# 2021/6185/P - 5 Albert Terrace, NW1 7SU

<b>Delegated Report</b>		<b>Analysis sheet</b>	<b>Expiry Date:</b>	14/02/2022
<b>(Members Briefing)</b>		N/A / attached	<b>Consultation Expiry Date:</b>	20/02/2022
<b>Officer</b>			<b>Application Number(s)</b>	
Miriam Baptist			2021/6185/P	
<b>Application Address</b>			<b>Drawing Numbers</b>	
5 Albert Terrace London NW1 7SU			See draft Decision Notice	
<b>PO 3/4</b>	<b>Area Team Signature</b>	<b>C&amp;UD</b>	<b>Authorised Officer Signature</b>	
<b>Proposal(s)</b>				
General façade alterations including replacement windows, works to front of the property including new balustrade to terrace and expansion of lightwell, installation of rear balcony and associated fenestration alterations, level changes and works to rear garden, and new skylights.				
<b>Recommendation(s):</b>		Grant conditional planning permission		
<b>Application Type:</b>		Householder Application

*Figure A: Proposed rear elevation*

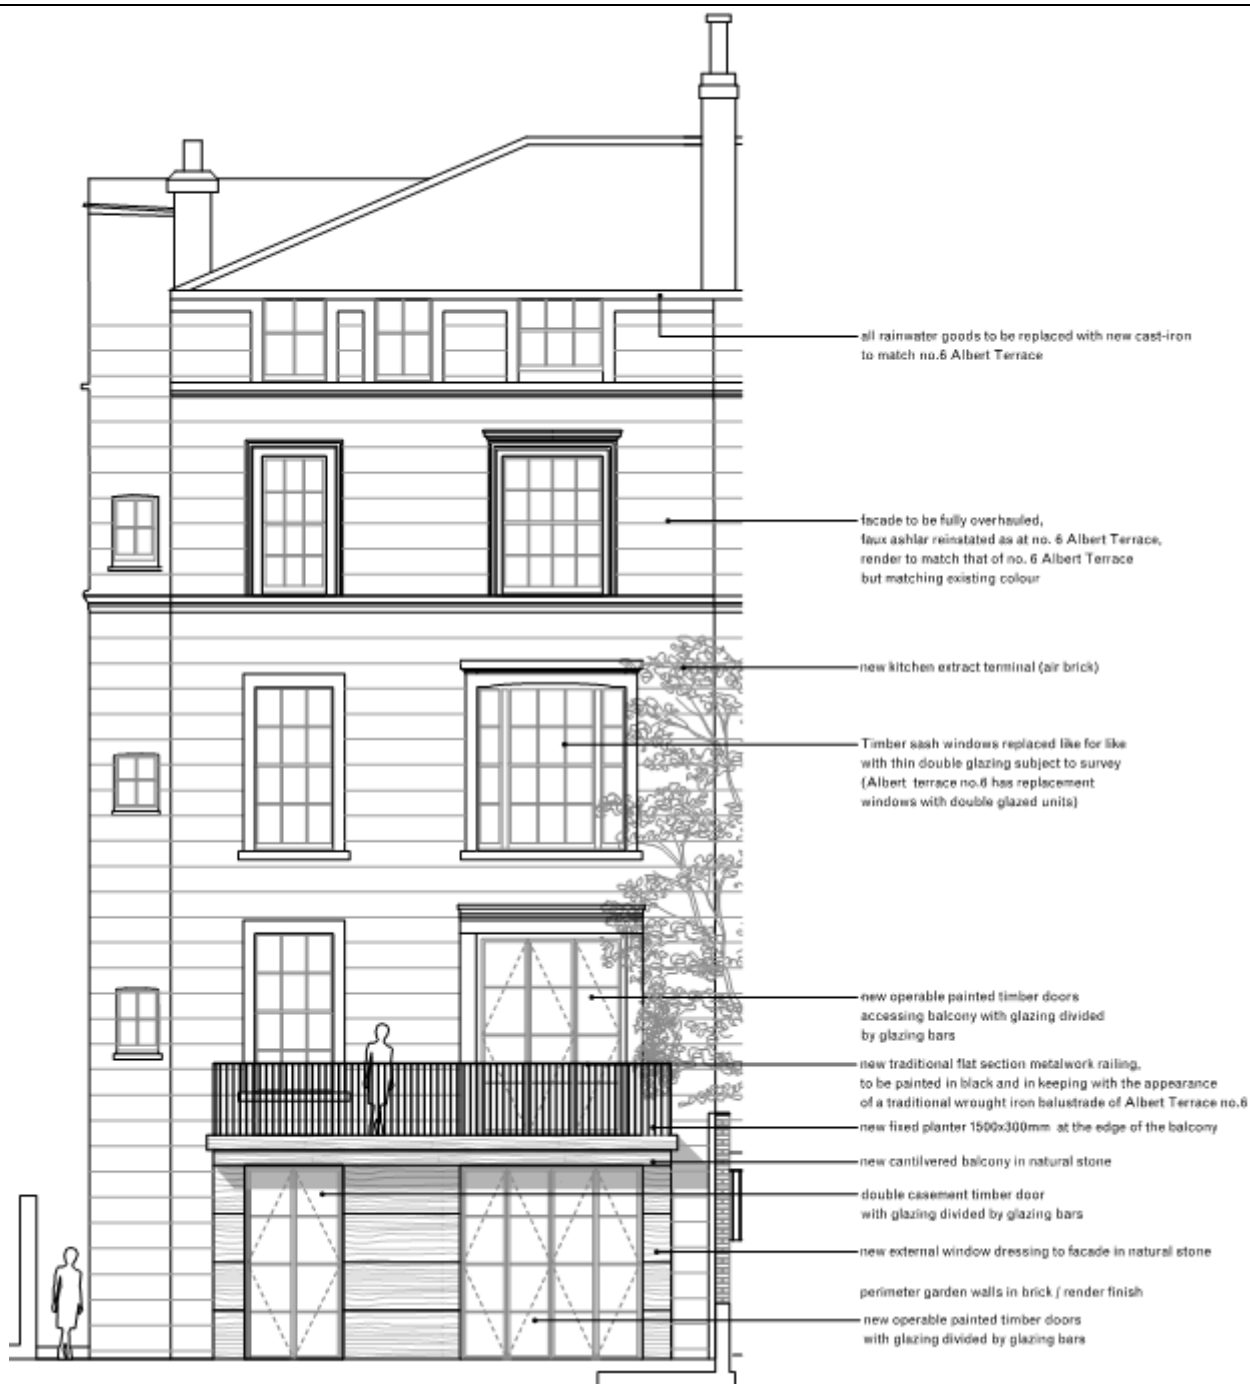
5. The proposed new fenestration/openings at the rear of the building are harmful to the character of the building: they introduce alien forms in a building of recognized significance, disrupting the rear elevation in terms of forms, proportions, balance, and details.

3.8 The rear elevation of No 5 is visible from the street beyond, Regents Park Road, from first floor upwards and will be more so when the trees drop their leaves. At first floor level a balcony will be installed below the two existing window openings. The balustrade would be a traditional metal vertical railing painted black which suits the character of the conservation area. The wider of the two window openings above will be replaced by glazed timber doors painted white which will occupy the same height and width as the original opening. Towards the boundary with No 6 there would be a fixed planter occupying the depth of the balcony at 1500cm and 30cm in width. The changes are considered acceptable as the proposal respects the existing hierarchy and dimensions of the original openings and uses the same material palette. Details such as the traditional balustrade also ensure the property is aligned with No 6 to which it is adjoined and reflect the details of the wider conservation area. Please see Figure A below.

*The changes to the openings to the rear of the building have been revised. Although the widest opening is being replaced with glazed doors, the conversion of the second window to a door has been omitted and the timber frame above the doors will be more prominent echoing the existing hierarchy, and that of the storeys above.*

3.9 The balcony slab itself will be natural stone, and below at lower ground level both current openings would be replaced by floor to ceiling, timber-framed glazing and the façade covered in natural stone. The alterations at this level would be more striking and modern, but would be well-concealed from the public realm and are not considered to harm the host property.
